## REPLACEMENT OF PIN PART NO. 929700 IN CARBURETOR FOR ROTAX® ENGINE TYPE 912/914 (SERIES) SB-912-048UL SB-914-033UL

## REPLACEMENT OF PIN PART NO. 929700 IN CARBURETOR FOR ROTAX® ENGINE TYPE 912/914 (SERIES) SB-912-048 SB-914-033

Replacement of pin part no. 929700 in carburetor for ROTAX® Engine Type 912/914 (Series)

engine  
912/914

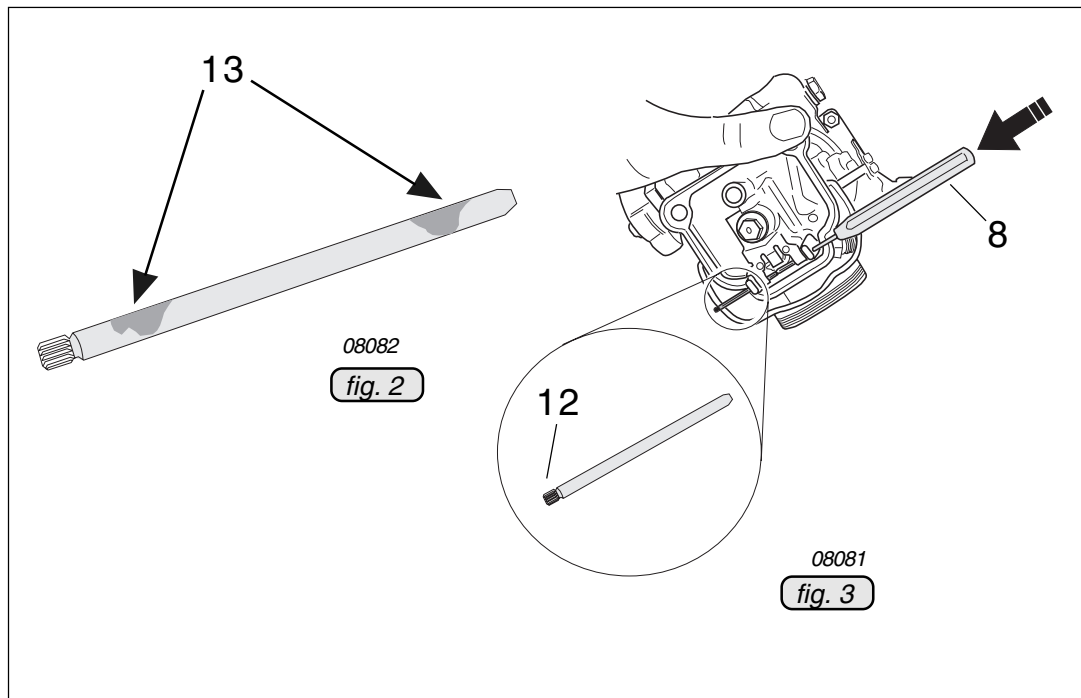
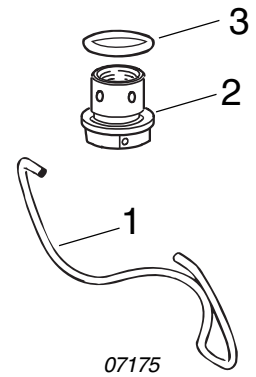
- Disconnect negative terminal of aircraft battery.
- Remove drip tray - if equipped.
- Remove carburetor.
- Open spring clip (1) or ROTAX<sup>®</sup> 914 (Series) open attachment screw (2) with o-ring (3).
- Remove float chamber (4) with gasket (5) and float (6).
- Remove pin (7) with appropriate pin punch (8) and remove float bracket (9) with float needle clip (10) and float needle valve (11)

◆ **NOTE:** The pin is serrated on one side (12). Put the pin punch on the opposite side and press out the pin. Don't damage the carb casting by pressing the serrated end through the pin support.

- Inspect the pin for flaking (13) of surface coating.
- Clean carburetor and fuel system, especially in case of flaking on the pin
- Check parts of carburetor.
- Install float bracket with float needle clip/float needle valve and the new pin part no. 929701
- Check if float suspension brackets are parallel and adjust if necessary.
- Install float chamber with gasket and float.
- Reassemble the carburetor.
- Install carburetor.
- Install drip tray - if equipped.
- Connect negative terminal of aircraft battery.
- perform basic throttle adjustment
